Addendum 3 – Regulation No. 4

Revision 3 - Corrigendum 1

Corrigendum 1 to Revision 3 of the Regulation (*Erratum by the secretariat*)

Uniform provisions concerning the approval of devices for the illumination of rear registration plates of power-driven vehicles and their trailers

Annex 4,

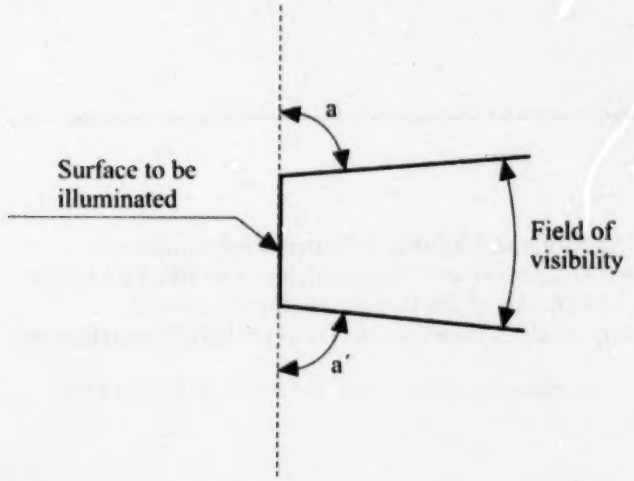
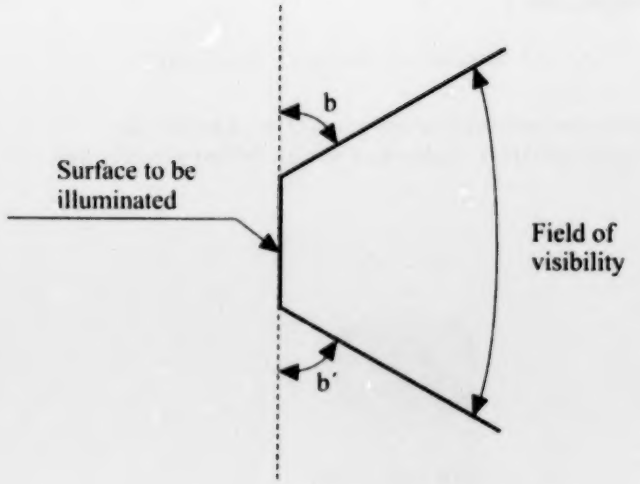
The figure, correct to read:

Vertical section

a and a´ should be ≤ 85°

Horizontal section

b and b´ should be ≤ 60°
